# Access Compliance Report

## Public Rights-of-Way

Intersection ID: 2407	Main Street: ACACIA_RIDGE_CT	Cross Street: HIDDEN_MEADOW_LN	Location:	N
ADA ID: 59789FE18332	Ramp Type: PerpDiag	Initial Pass/Fail: Fail	Overall Compliance: No	Severity Score: 21.25

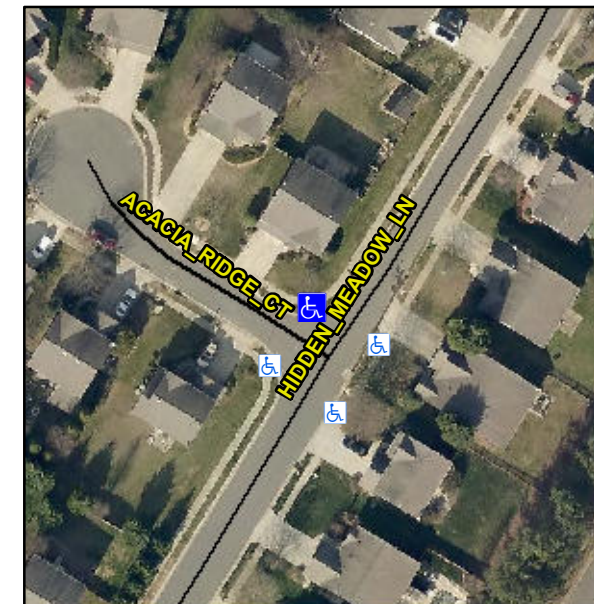
**R304.5.1, R304.5.3**

Compliance	Description	Data	Compliance	Description	Data
N/A	Ramp Length (in)	47.0	Yes	Ramp Slope (%)	5.8
No	Ramp Width (in)	43.0	No	Ramp XSlope (%)	5.1
N/A	Flare Type LT	N/A	N/A	Flare Type RT	N/A
N/A	Flare Slope LT (%)	N/A	N/A	Flare Slope RT (%)	N/A
N/A	Flare Traversable LT?	N/A	N/A	Flare Traversable RT?	N/A
N/A	Landing Length (in)	N/A	N/A	DWS Provided?	N/A
N/A	Landing Width (in)	N/A	N/A	DWS Contrast?	N/A
N/A	Landing Slope (%)	N/A	N/A	DWS Length (in)	N/A
N/A	Landing X Slope (%)	N/A	N/A	DWS Full Width?	N/A
N/A	Landing Curb? (Y/N)	N/A	N/A	DWS Offset (in)	N/A
N/A	Shared Landing?	N/A			
N/A	Gutter Ponding?	N/A	N/A	Gutter Slope (%)	N/A
N/A	Gutter Lip Ht (in)	N/A	N/A	Gutter X Slope (%)	N/A
N/A	Painted X Walk1?	No	N/A	Painted X Walk2?	No
	X Walk 1 Direction	To SW		X Walk 2 Direction	To SE
N/A	X Walk 1 Width (in)	N/A	N/A	X Walk 2 Width (in)	N/A
	X Walk 1 Slope (%)	1.7		X Walk 2 Slope (%)	5.2
	X Walk 1 X Slope (%)	4.3		X Walk 2 X Slope (%)	1.2

**Remove & Replace Curb Ramp With Two New Directional Ramps or Equivalent.**
